# RESPONSE TO SUBMISSIONS

Taronga Zoo  
Upper Australia Precinct

Prepared for  
**TARONGA CONSERVATION SOCIETY AUSTRALIA**  
9 November 2020

Figure 1 – Plan showing distance between new fence and existing masonry wall

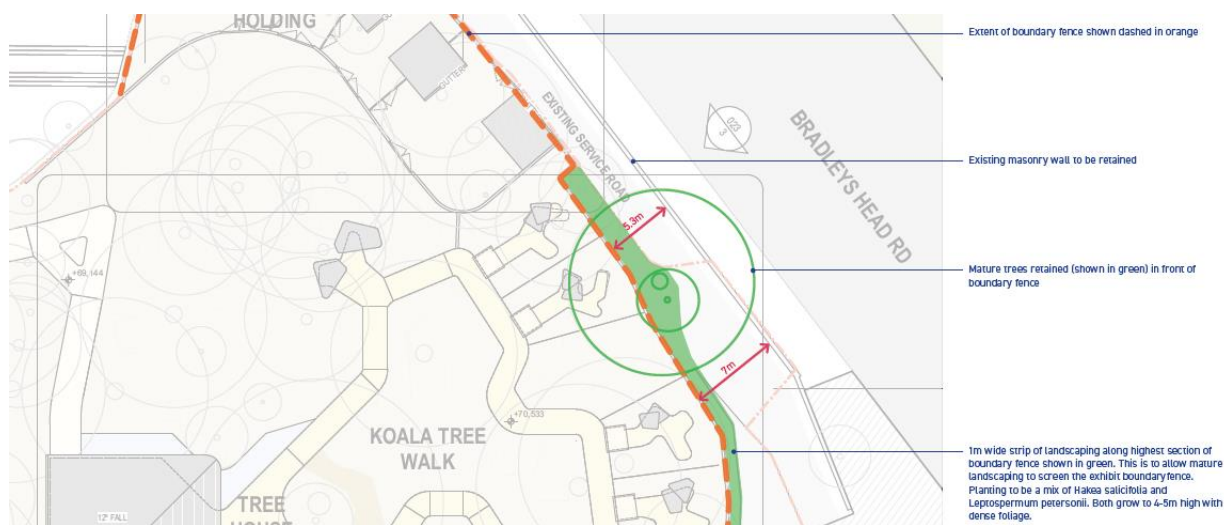
- NSW Heritage Council (HNSW) provided the following comments:
  - HNSW requests further visual information (ie. photomontage and design palate) regarding the interface of the new fencing partition on Bradleys Head Road and the sandstone boundary wall.

Submissions received by Heritage NSW and Mosman Council requested additional details in relation to the new fence on Bradley’s Head Road. Additional information has been prepared by Lahznimmo and Spackman Mossop Michaels (**Appendix A**) to illustrate how the wall relates to the existing masonry wall and the overall landscaping of the area.

The fence has been designed at a certain height for the protection of the animals and provides connections to the overall themes of the Upper Australia Precinct. The location of the fence and additional planting are considered a suitable distance to ensure there are no impacts on the heritage significance of the masonry wall. Mature native plantings including a mix of willow-leaved hakea (*Hakea salicifolia*) and teatrees (*Leptospermum petersonii*) are proposed along the site boundary. Both species will grow between 4-5 metres high with dense foliage to a natural element between the masonry wall and new fence.
